SUBJECT: Forwards response to 841219 telcon addressing Sandia recommendations for improvement in human factor engineering of BWR Owners Group graphic display sys. Discussion of signal validation logic also encl.

January 31, 1985  
G02-85-047

Subject: NUCLEAR PLANT NO. 2  
GRAPHIC DISPLAY SYSTEM HUMAN FACTORS

Figure 1

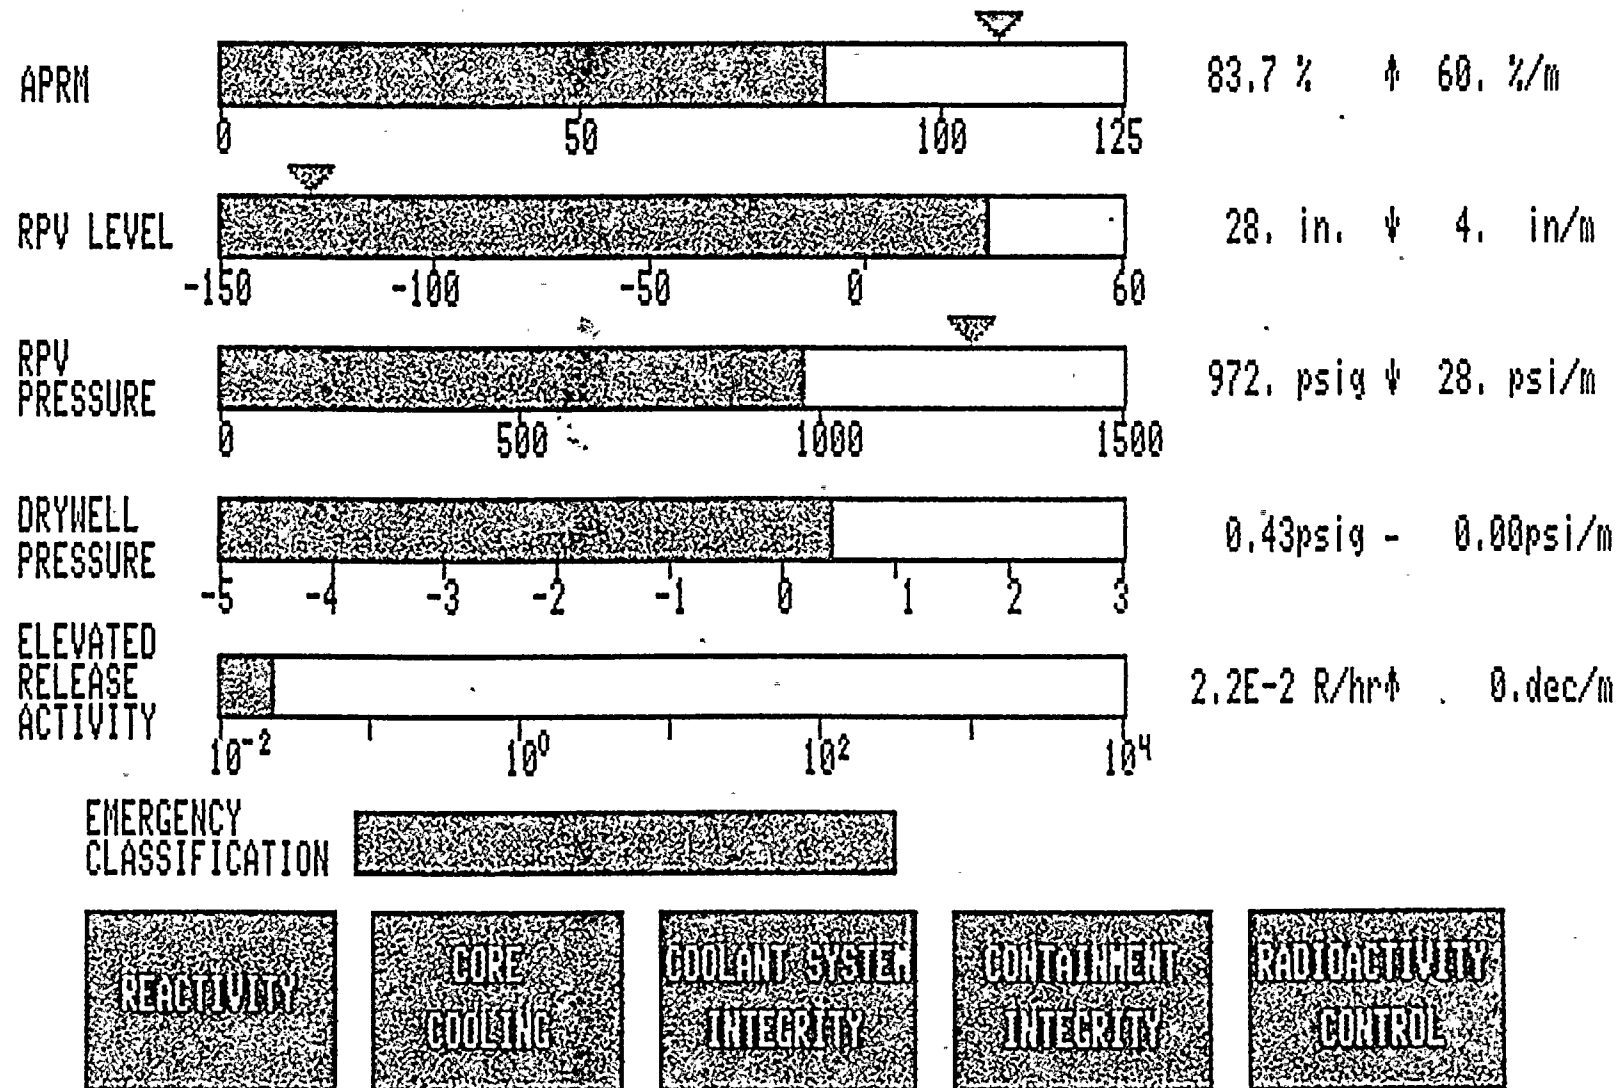
The bar displays presents a series of horizontal bars. Each bar represents a single parameter. The value of a parameter is determined from the length of the bar. In the GDS, all of the bars were oriented in the direction of the x axis.

The scales should be long enough that the operator can visually discriminate small but significant changes in direction of the bars. In the GDS, the length of the scale is limited by the dimensions of the CRT. In the practical sense, the most effective action option is to make the scale as long as the system will allow. Additional length can be obtained by:

Many of the critical tic marks were not labeled. Some of the operators expressed concern about this omission, particularly with regard to the absence of the alarm setpoint values. Labels should be provided for all critical tic marks.

The operators often commented that the tic marks were too small. The length of the tic marks should be increased. This may be accomplished by extending the tics into the body of the bar and/or by decreasing the width of the bars and extending the tics into the resulting space below the bar.

Operators commented on absence of color coding of the quantitative readouts. The use of color to indicate status would aid in the rapid comprehension of system status from the readouts.

The length of the bars on the WNP-2 displays were increased 23% and additional scaling values were added to improve the ability to discriminate changes in a parameter at a glance.

The labeling of tic marks was not incorporated due to the added clutter it creates. It was also assumed that a good operator knows what every alarm setpoint in the Technical Specifications is and, to date, our operators have never questioned what a tic mark represents.

The tic marks were completely redesigned to take the form of a triangle at the top of each bar. This increase in size has resolved this problem.

Color coding the numerical readouts for each parameter is a requirement of the design specification. That is to say, if the parameter exceeds a yellow or red alarm setpoint, the numerical readout of the parameter and the bar are supposed to change colors to yellow or red also. Due to software difficulties, the numerals do not change colors; however, the bars do. This is an outstanding issue at this time; however, as a result of upcoming computer changes, we expect to incorporate this improvement in the future along with a change to increase the size of the numerical readouts to the same height as the bar. We do not consider this a serious deficiency since there have never been any comments from our users regarding this issue.

Many of the specific comments regarding each bar display were also incorporated. In addition, several parameters used mostly for daily operations were added as an incentive to encourage daily use of the displays. An example of a bar display is provided in Figure 1.

- Figure 2

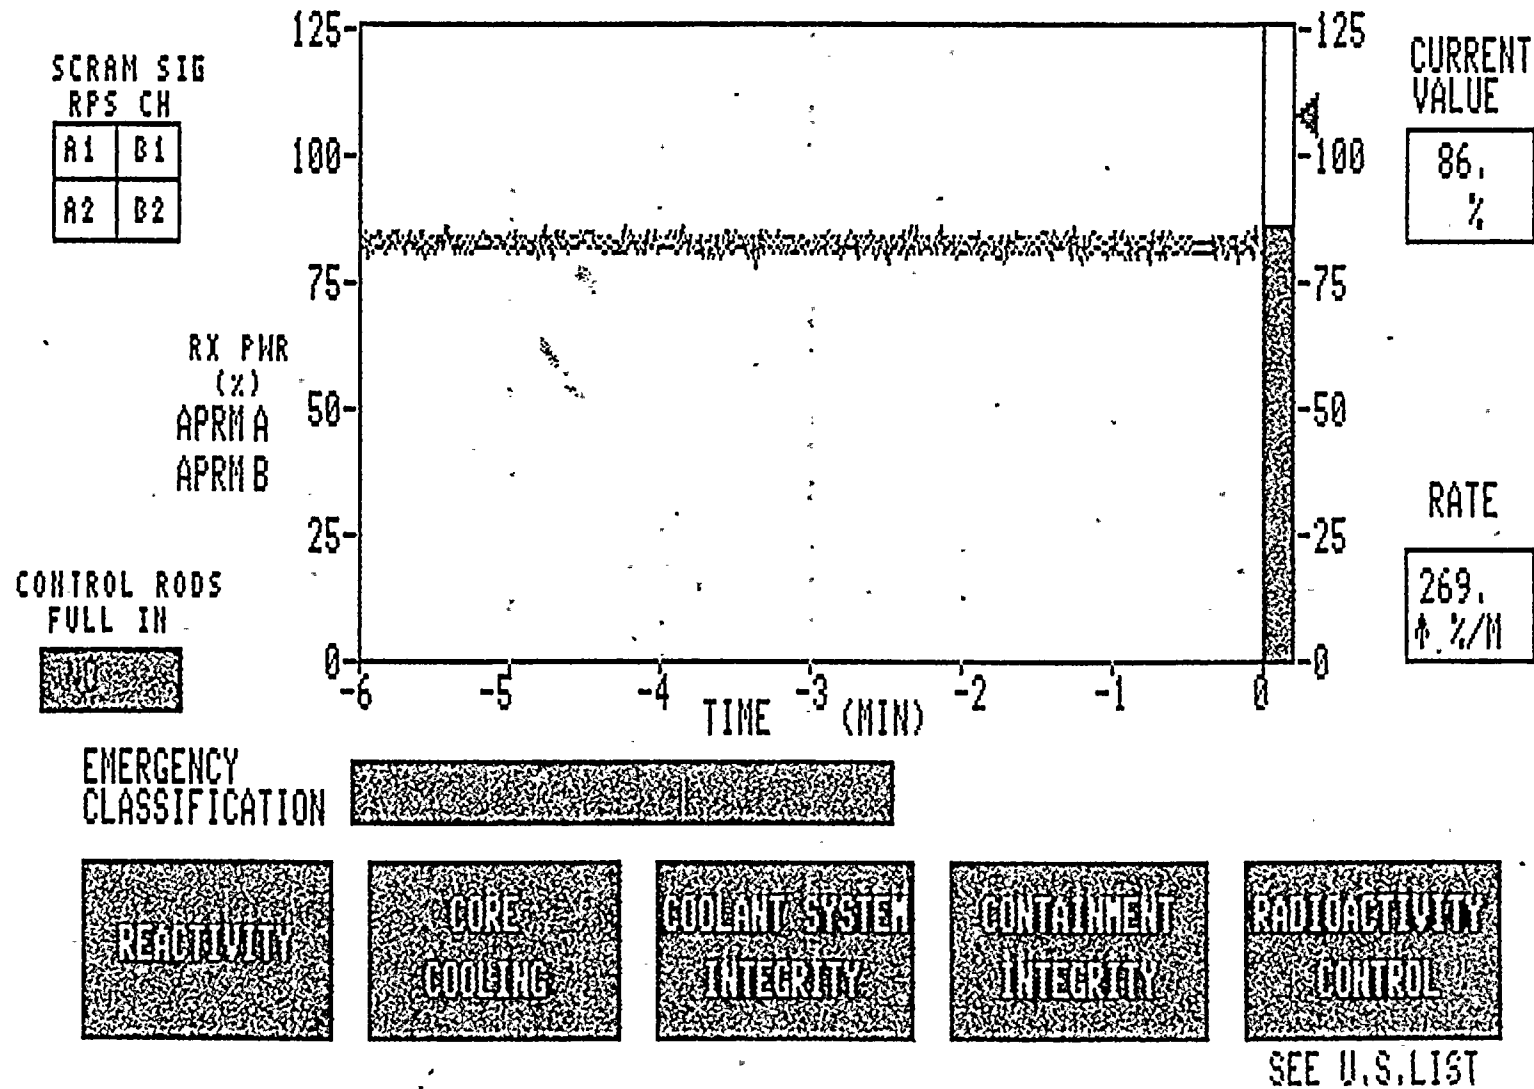
The primary usability problems reported by the operators was the difficulty in reading the display due to the limited length of the vertical scales, particularly on displays containing two or more graphs.

As in the case of the bar displays, the operators were concerned that the critical tic marks were not identified and the alarm setpoint values were not indicated. It was also noted that the units of measure of the readouts were not always identified. The displays should be redesigned to incorporate these features.

Operators commented on the absence of a y scale on the right side of the graph. The time history of the trend displays progresses from left to right with the most current value always on the right. No scale markings exist on the right side of the graph. The scale markings should be provided where they can be used by the operators, preferably on both vertical sides of the graph, or, if that is not feasible, on the right side of the graph. The tic marks should be made longer by extending them through the body of the graph as is done in the RPV Level (Fuel Zone)/RPV Pressure display.

The call-up time for the multiple displays ranged up to 14 seconds. A number of operators indicated that this was too slow. The reaction time of the system should be reduced.

The trend lines and readout boxes did not change color with a change of status. If both items made the same use of color as the bars in the bar displays, speed of detection of status changes would be aided.

In multiple graph displays, the operators reported difficulty in relating the readout boxes to the proper graphs. To aid operators in identifying the correct readings, the upper or lower border of the box could be eliminated and the box raised or lowered, as appropriate, to meet the border of the graph with which it is associated. Whatever the design solution, it should be employed consistently throughout all of the trend displays.

The problem of small scales was resolved on the WNP-2 GDS by displaying only one parameter trend at a time; plus having the option to display all trends for each safety group at the same time. In this way we have the best of both worlds. In addition, there are three colorgraphic CRT's in the operating zone of the control room. For each trend display, the trend area is maximized on the CRT to provide maximum clarity and detect small changes. Also, it has been found that the time scale for some parameters should be longer than six minutes and were changed accordingly. The reactor vessel mimic was deleted on all displays to make room for larger trends. Also, in an effort to bring the advantages of the bar display to the trend display, a vertical bar was added to each trend.

Tic mark labeling was not deemed significant and, in fact, causes problems with clutter. Refer to our response in the Bar Display section.

All our trend displays have scales on both sides of the trend. Tic marks have been improved by using larger color coded triangles.

Display call-up times for all singular displays varies from 7 to 14 seconds for the first time it is called up. After a display has been called up once and then is asked for a second time (i.e., after going to another display), it will be displayed in less than 2 seconds. Multiple trend displays take approximately 30 seconds to become active. These times are not much of an improvement over the original BWROG displays, but this is limited by the current technology, not our desire to improve it.

The WNP-2 GDS displays incorporated a vertical bar which changes color according to alarm points. This, along with the color change in the readout boxes, aids in the detection of status change changes.

This is a non-problem since all our trend displays are singular parameter displays.

In addition to the short term real time trends provided by the standard set of GDS displays, the STA console, TSC consoles, and EOF consoles all have the capability of calling up "GDS Historical" displays which consist of extended time scales of all GDS trends. There are 6 time scale options as follows: 1 hour, 8 hours, 24 hours, 48 hours, One week and Two weeks. A hard copy color printout capability is also being added in early 1985. Figures 1, 2, and 3 are examples of this capability. An example of trend displays is provided in Figure 2.

Figure 3

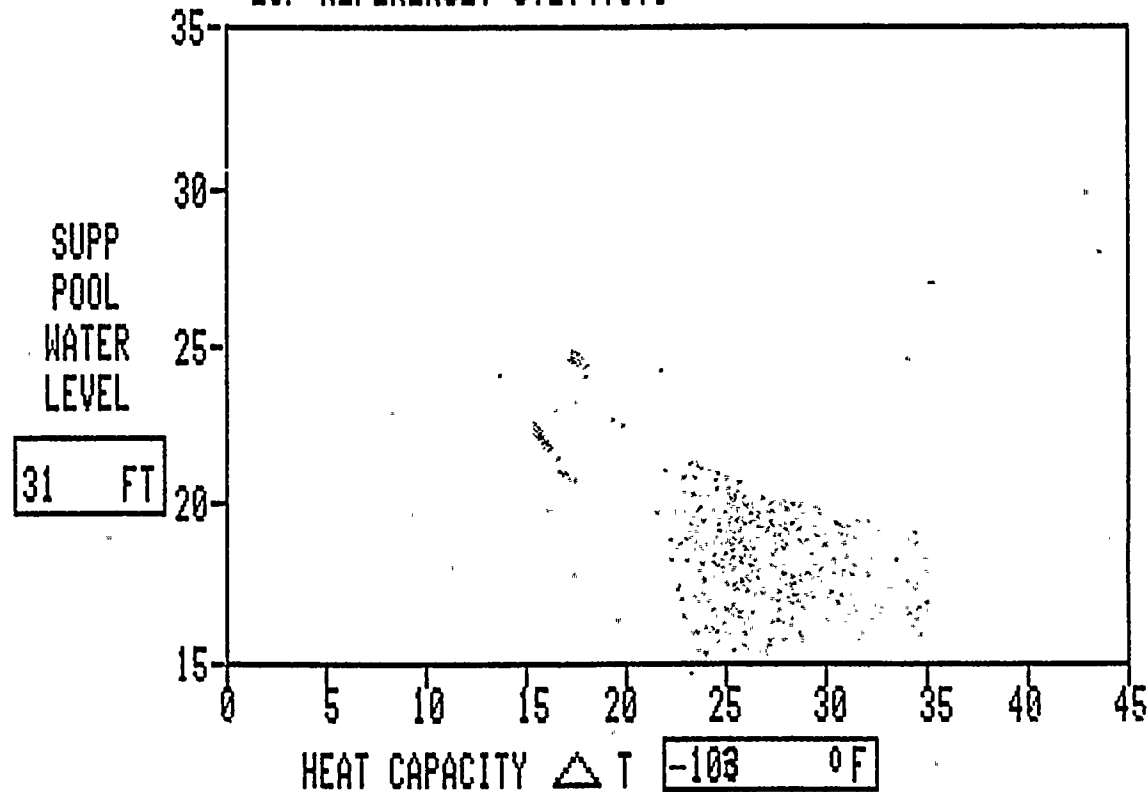
*The position marker (x) presently used interferes with the operators' ability to read a value when it approaches the boundary of the graph or when the trend line moves in the same direction as one of the legs of the x. The x should be replaced with an open-centered x, or a circle, or a triangle so that it does not cover needed information.*

*The labeling of the x axis was typically located along side the upper horizontal boundary of the graph. The placement confused many of the operators because of the stereotyped expectation that this location is used for labeling the y axis.*

The WNP-2 GDS uses an equal-armed rectilinear cross (+) with a red dot in the middle. When the cross moves, the red dot stays and leaves a trail of where it's been and provides insight into which direction it's trending. As it approaches the limit boundary and subsequently crosses it, there is no interference with the operators' ability to know the relationship between the center of the cross and the boundary line. This is primarily due to the red center of the blue cross.

The labeling of these displays is in the same location and similar format as all other displays and, thus, the confusion experienced on the BWROG displays was eliminated. In addition, all units are defined on the same axis as the scale, and all titles are in the upper left hand corner opposite the time.

To aid in the interface with the Emergency Operating Procedures, these displays provide a reference to the specific section of the Chapter 5 Emergency Operating Procedures (EOP) to which each display is used. Some displays have more than one reference.
